**Methods for the calibration of
vibration and shock transducers —**

**Shock calibration by comparison to a
reference transducer**

AMENDMENT 1

Reference number
ISO 16063-22:2005/Amd.1:2014(E)

Figure C.1 — Ratio of wave speed to nominal wave speed as a function of bar radius to wavelength for a Poisson’s ratio of 0,29

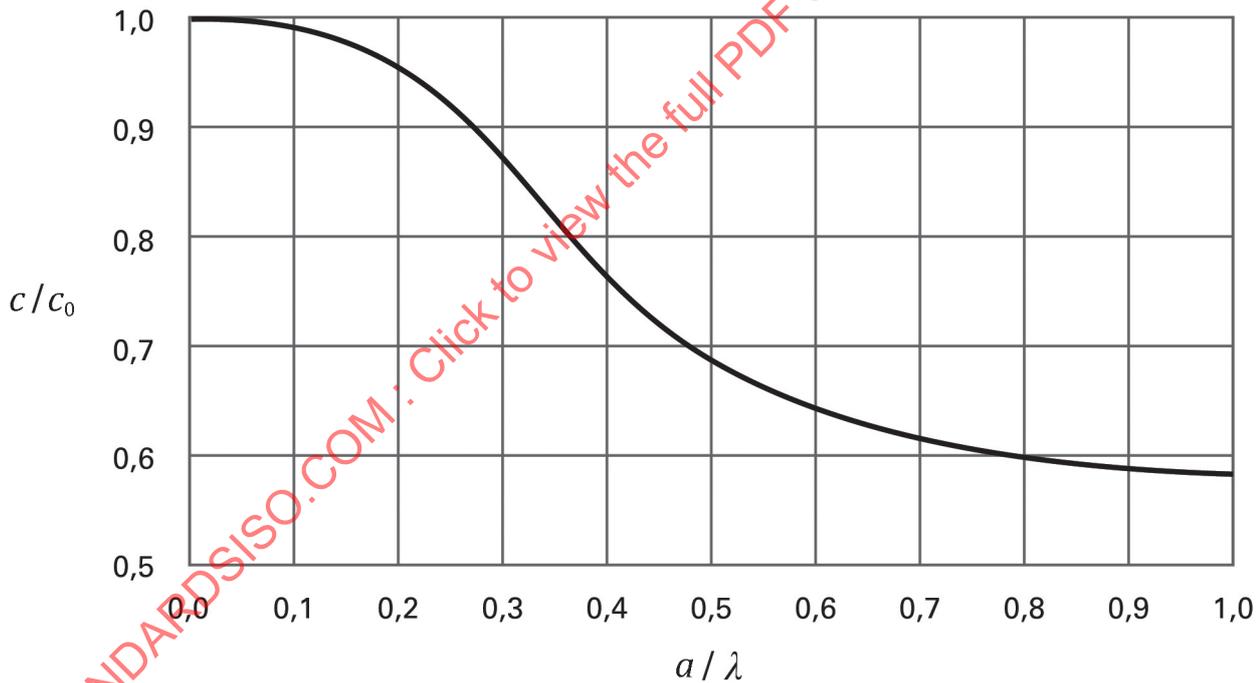
New page 22, Annex C

Insert the following new annex, following Annex B:

Dispersion in bars

Dispersion in a long slender bar (Kolsky bar, Davies bar, Hopkinson bar etc.) is caused by different frequencies in a shock pulse travelling at different wave speeds. This occurs where the ratio between c [the wave speed for a particular wavelength (frequency)] and c_0 [the nominal wave speed for infinitely long waves in the bar (based on material properties)] is less than 1,0 or

Dispersion appears as apparent frequency content on the time history measurement of the shock pulse; however, a discrete Fourier transform will not show the frequency that appears in the time history. The apparent frequency content is caused by the phase difference between the frequency components in the shock pulse. This phenomenon has been well known for centuries and is documented in several classical references.^{[5] [6]} Figure C.1 shows the ratio of wave speed (also known as *phase velocity*) to the nominal wave speed (wave speed for an infinite wavelength) as a function of the ratio of the radius, a , of a bar to wavelength, λ , for the first root of the “frequency equation”.^{[5] [6]}
